ERRATA

July 2015

Errata to *Roadside Design Guide*, 4th Edition

EXAMPLE 3-D

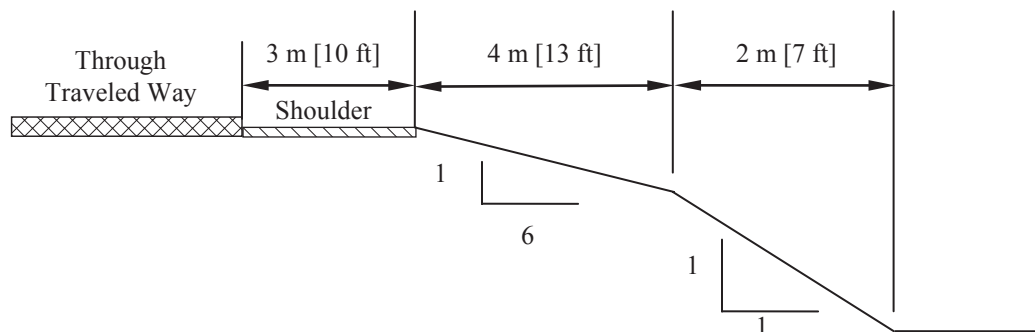
Design ADT	Backslope																																															
	1V:3H	1V:5H to 1V:4H	1V:6H or Flatter																																													
Under 750	7–10	7–10	7–10																																													
750–1500	12–14	12–14	12–14																																													
1500–6000	14–16	14–16	14–16																																													
Over 6000	16–18	16–18	16–18																																													
Design ADT	Backslope																																															
	1V:3H	1V:5H to 1V:4H	1V:6H or Flatter																																													
Under 750	7–10	7–10	7–10																																													
750–1500	10–12	10–12	10–12																																													
1500–6000	12–14	12–14	12–14																																													
Over 6000	14–16	14–16	14–16																																													
3-21	Example 3-D does not have “Discussion” text to follow after the figure.	Add the following text: “Discussion—Since the critical foreslope is within the suggested clear-zone distance of 9 to 10.5 m [30 to 34 ft], it should be flattened if practical or considered for shielding. However, if this is an isolated obstacle and the roadway has no significant crash history, it may be appropriate to do little more than delineate the drop-off in lieu of foreslope flattening or shielding.”

Discussion—Since the critical foreslope is within the suggested clear-zone distance of 9 to 10.5 m [30 to 34 ft], it should be flattened if practical or considered for shielding. However, if this is an isolated obstacle and the roadway has no significant crash history, it may be appropriate to do little more than delineate the drop-off in lieu of foreslope flattening or shielding.

EXAMPLE 3-K

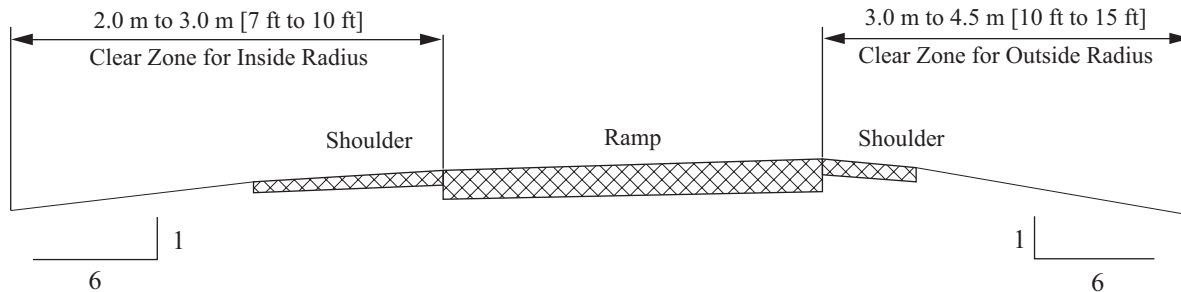
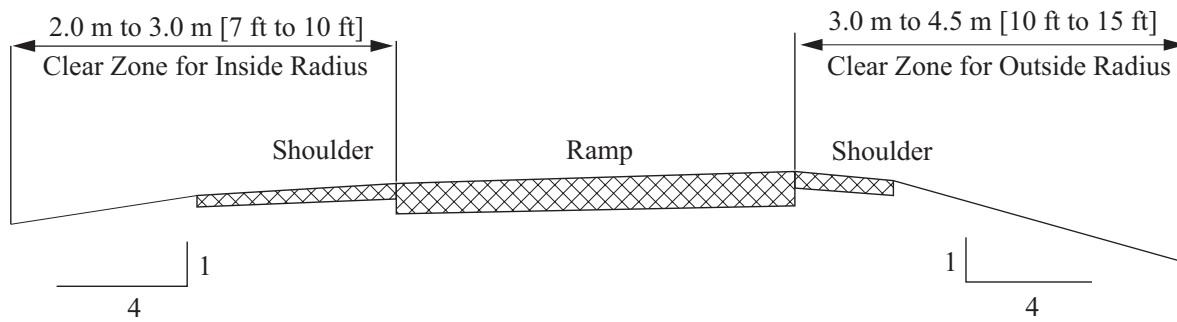
3-26	Example 3-K, Curve 2—The cross sections in the figure need to be banked the opposite direction in order to correspond to the plan view as shown on page 3-27. Also, the dimension “[11 to 15 ft]” should be changed to “[10 to 15 ft].”	Substitute Example 3-K with the attached revised figure.																																														
3-28	Example 3-L, Curves 2 and 3—The cross sections in the figure need to be banked the opposite direction in order to correspond to the plan view as shown on page 3-29. Also, the dimension “[10.5 to 15 ft]” for Curve 2 should be changed to “[10 to 15 ft].”	Substitute Example 3-L with the attached revised figures.																																														
3-29	Example 3-L, Curve 4—The dimension “[14 to 16.8 ft]” for Curve 4 should be changed to “[14 to 16 ft].”	Substitute Example 3-L with the attached revised figure.
